Development Review Committee (DRC) Meeting

The applicant is requesting approval of an Overall Development Plan for 126 Townhome units off of East Highbanks Road.

OVERALL DEVELOPMENT PLANS FOR Highbanks Townhomes

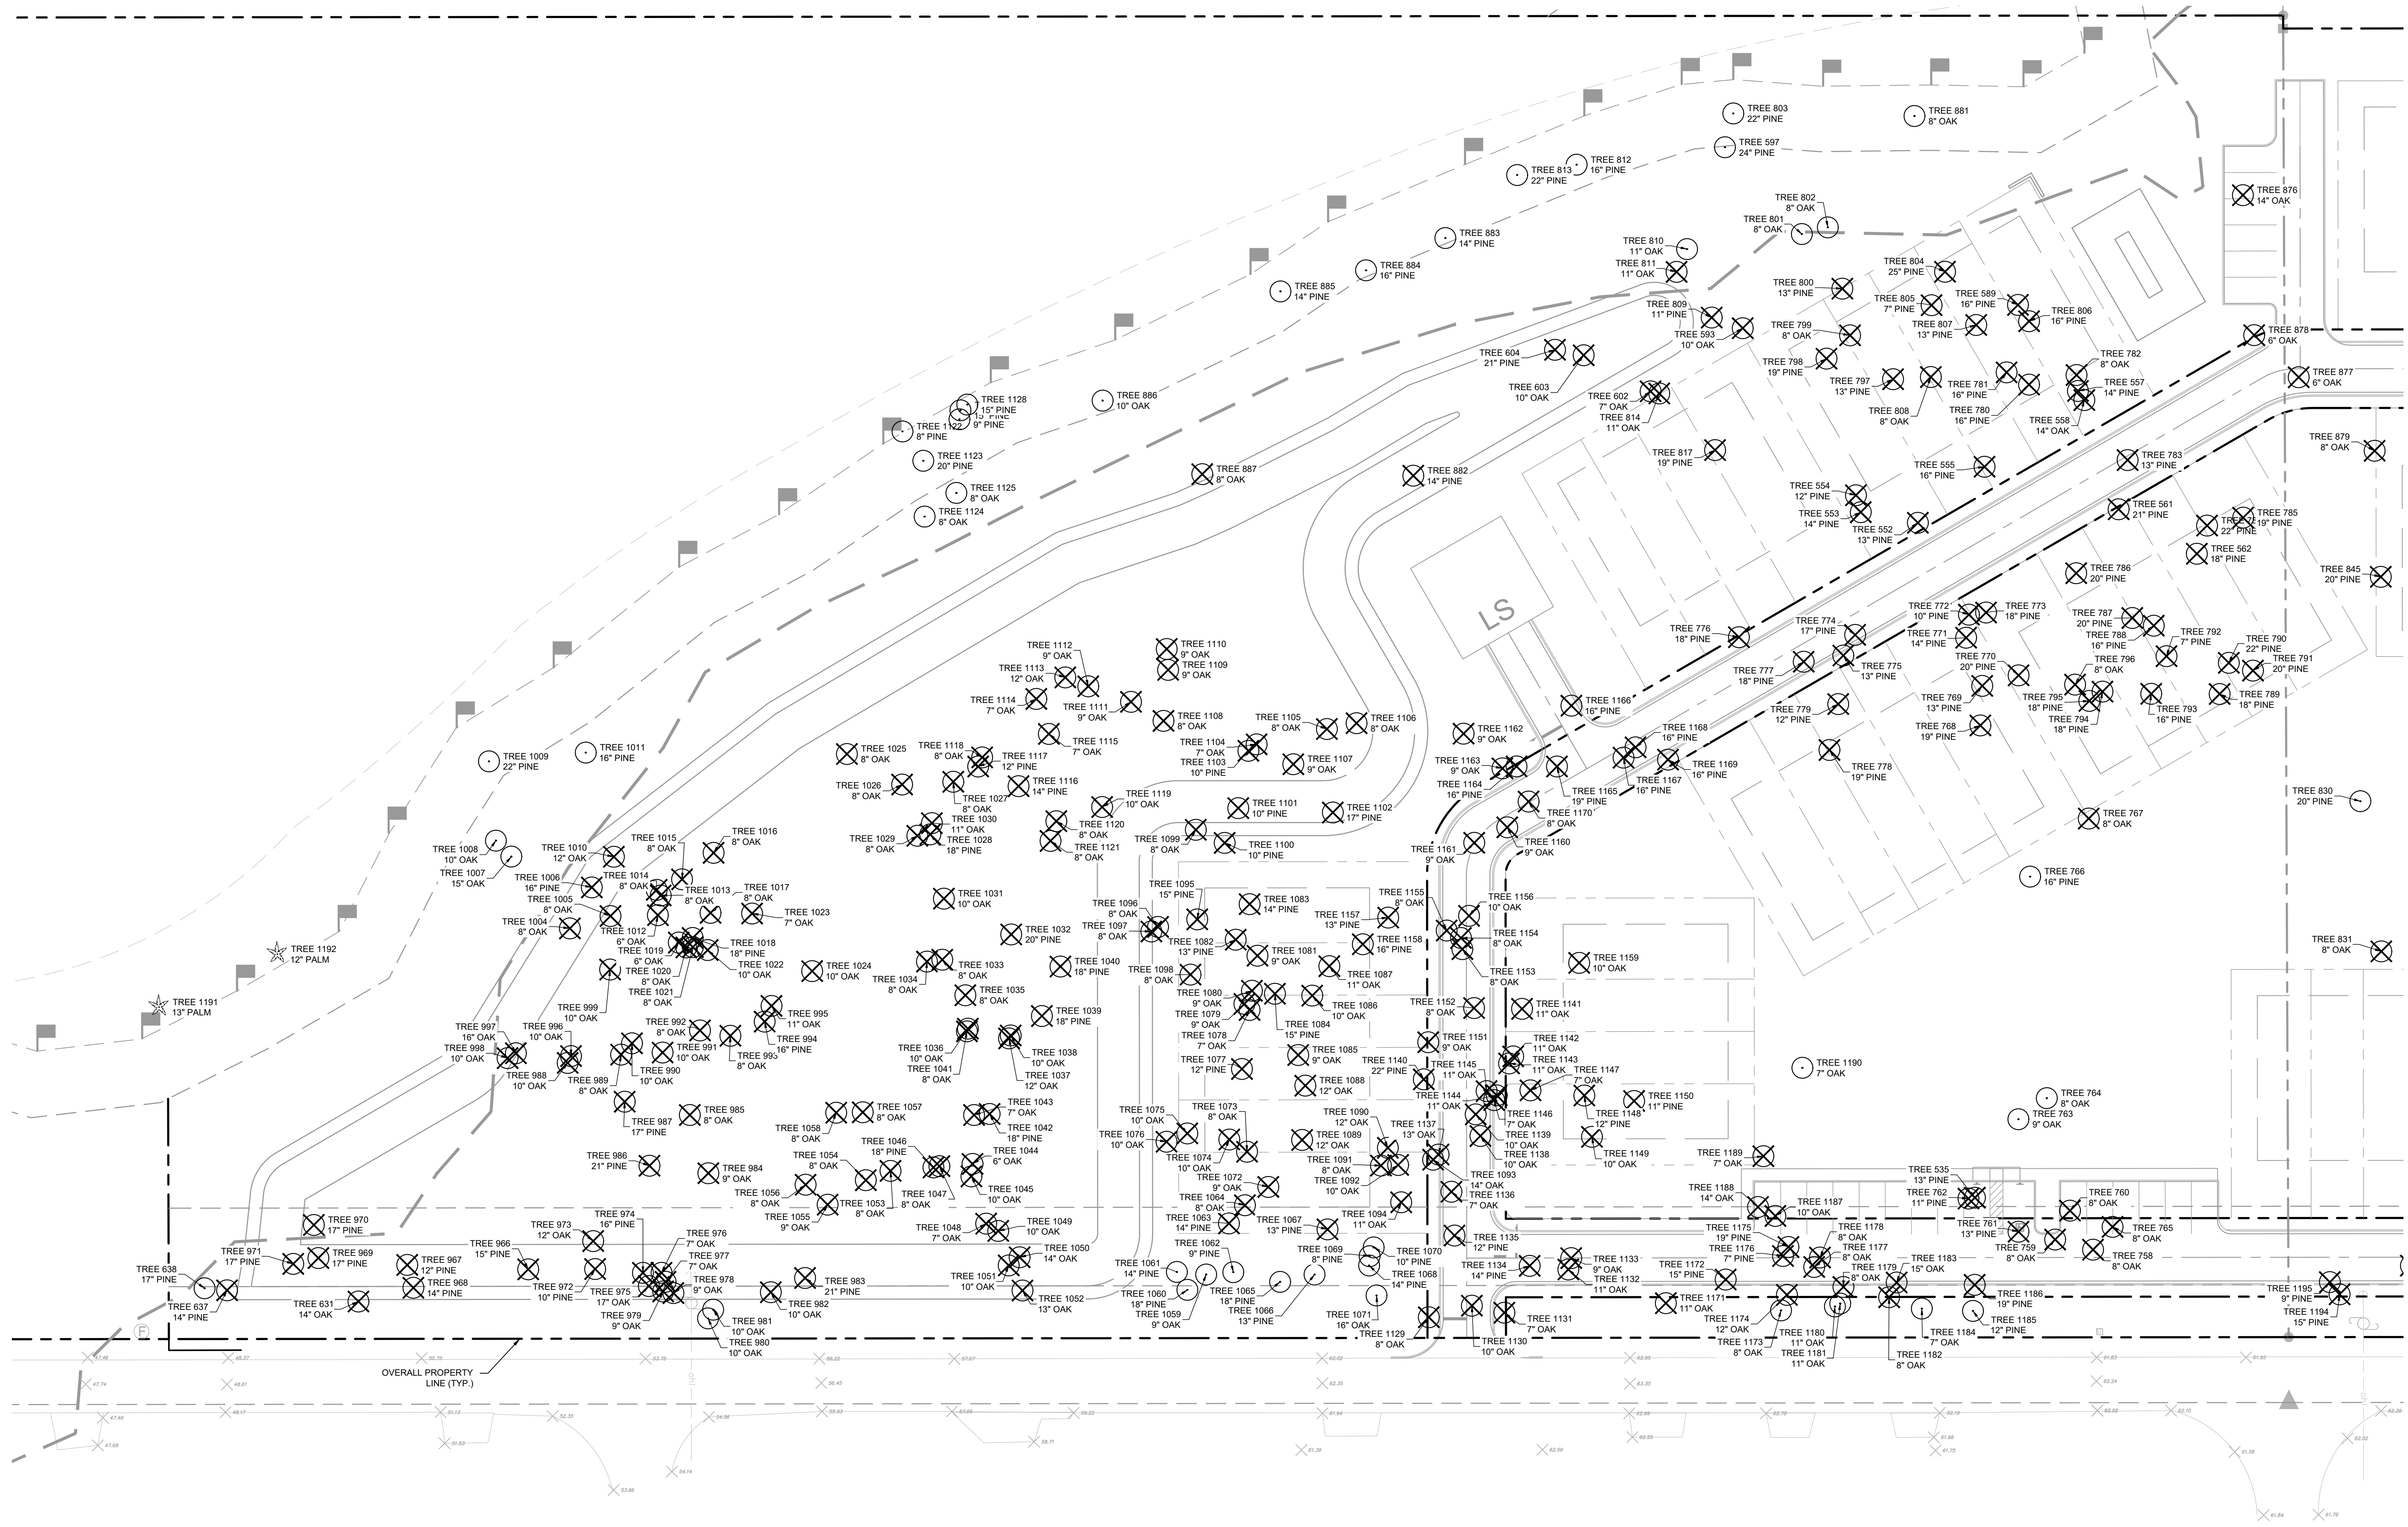
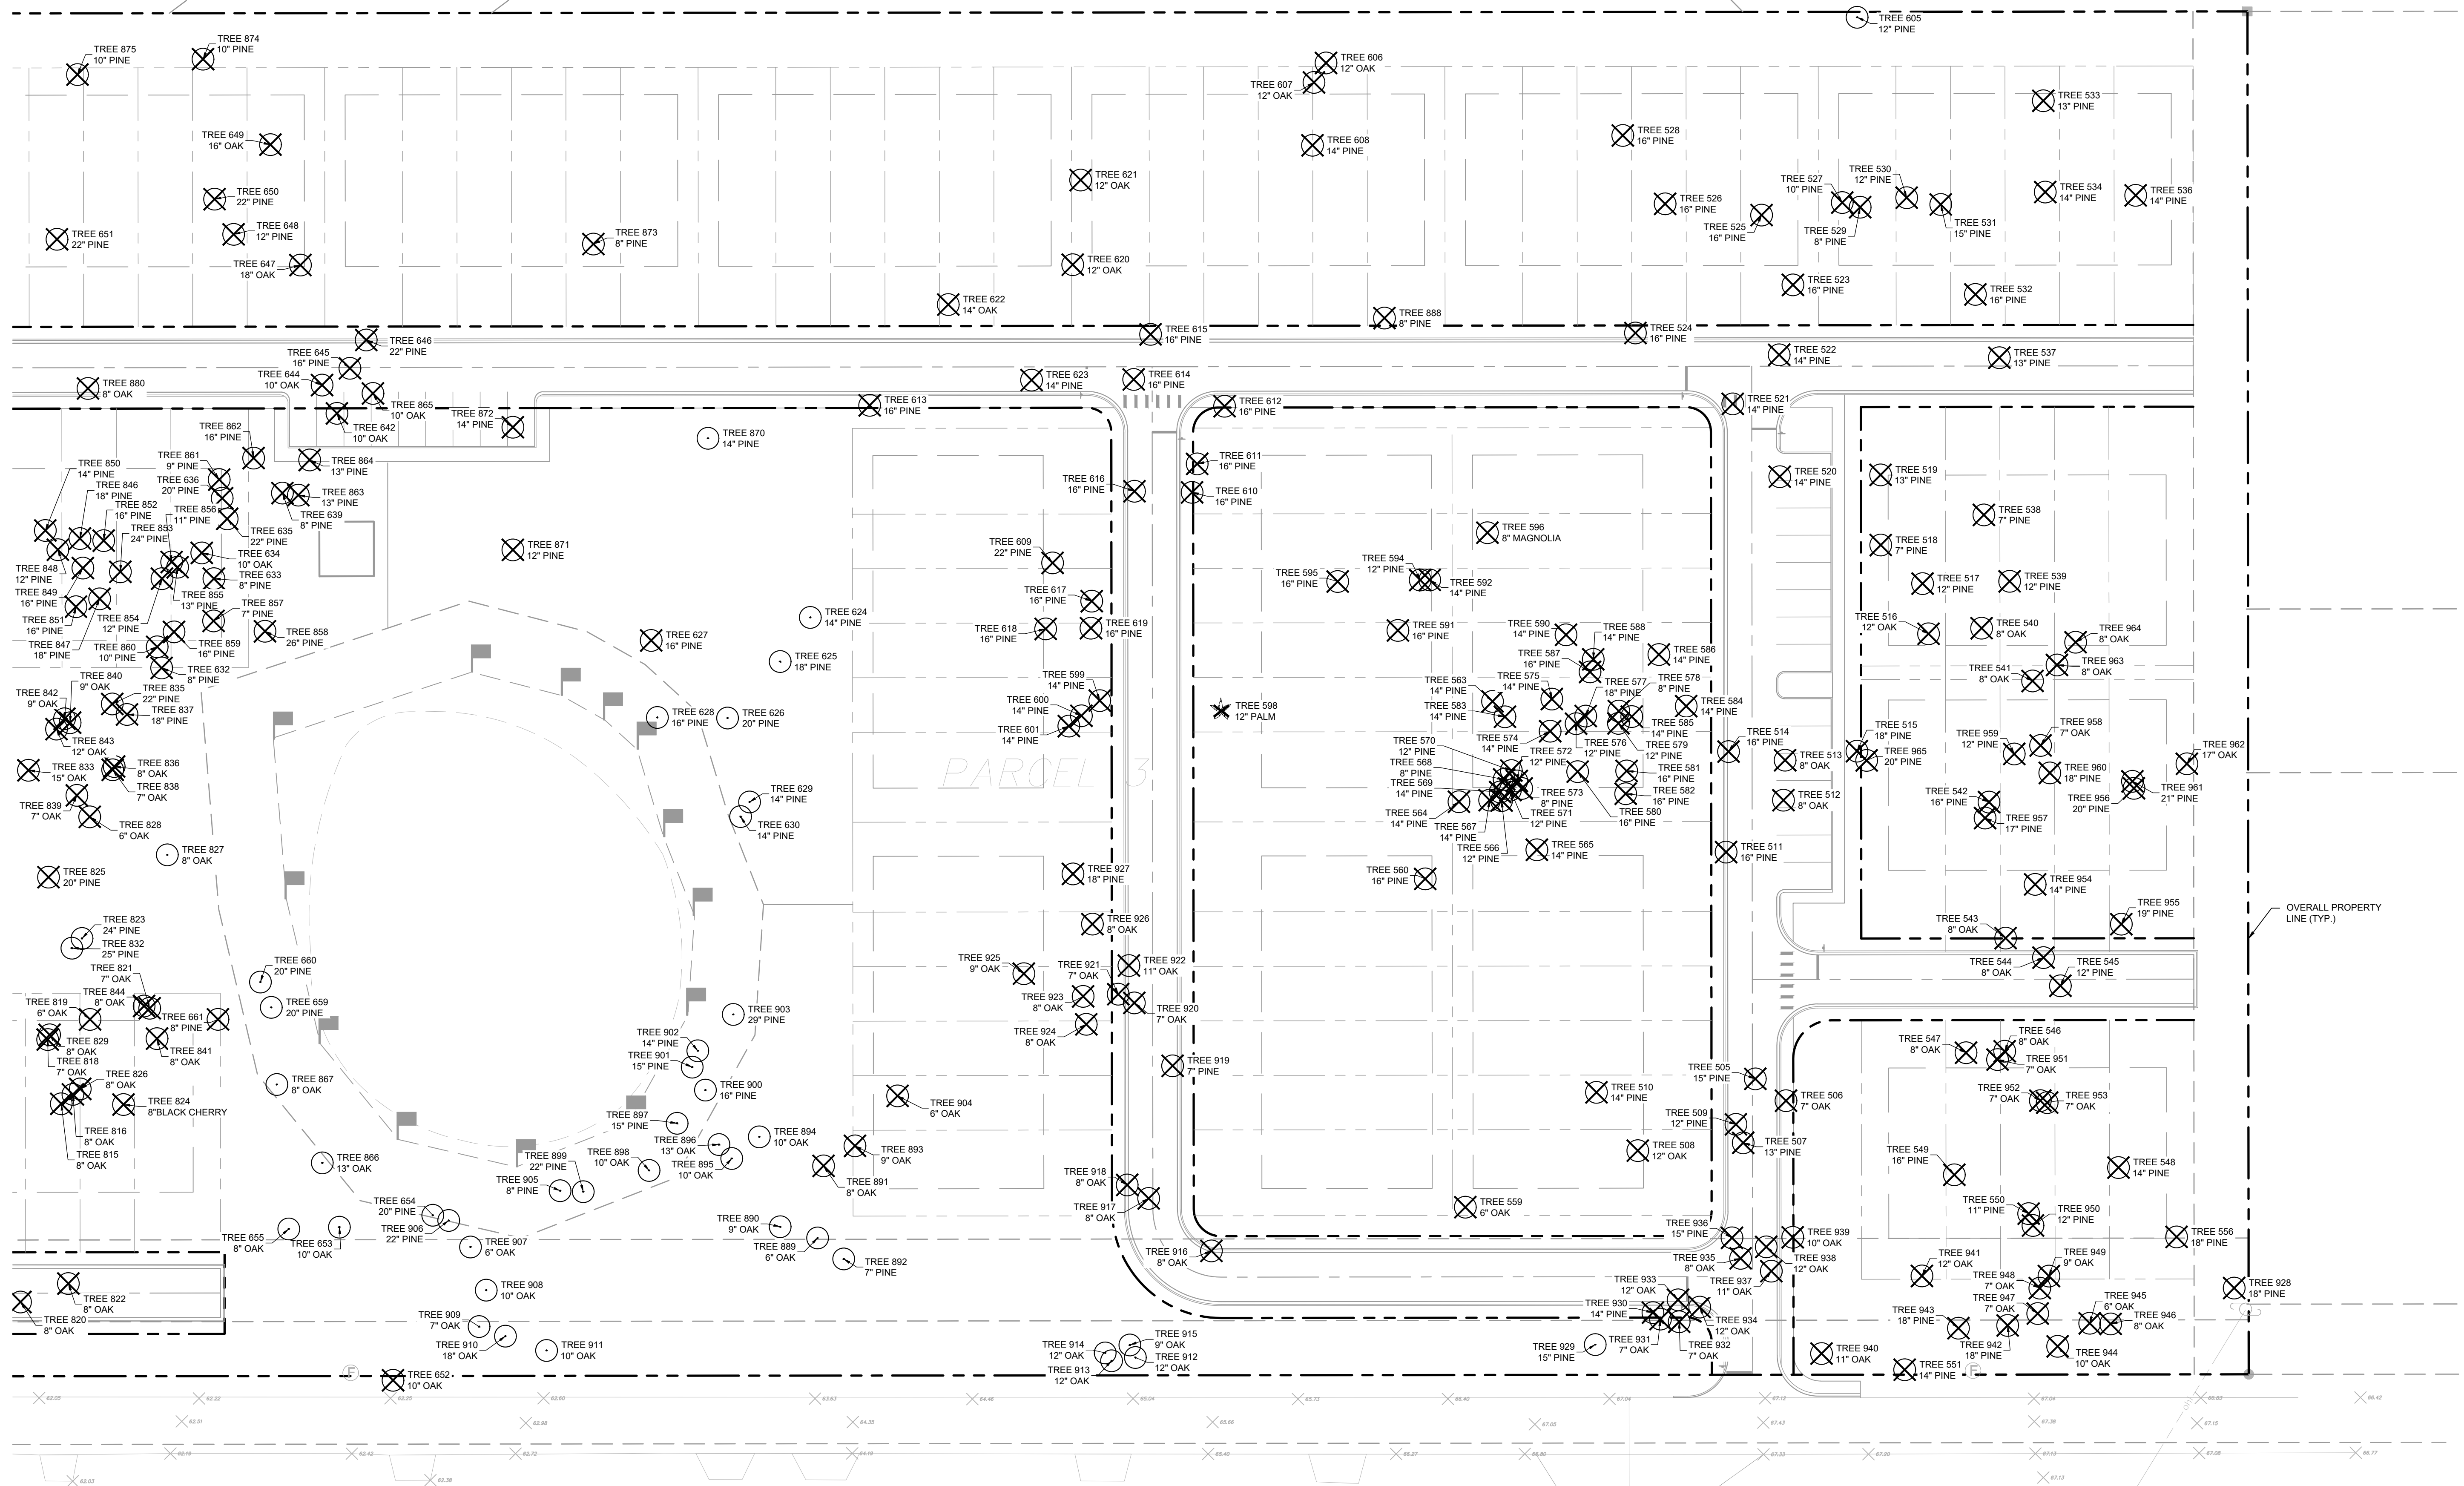
1. Per Sec 5-88, Please show the designated tree protection areas on sheets L0.50, L0.51 and L0.52. Additionally, please include the square footage calculations of each designated tree protection area.
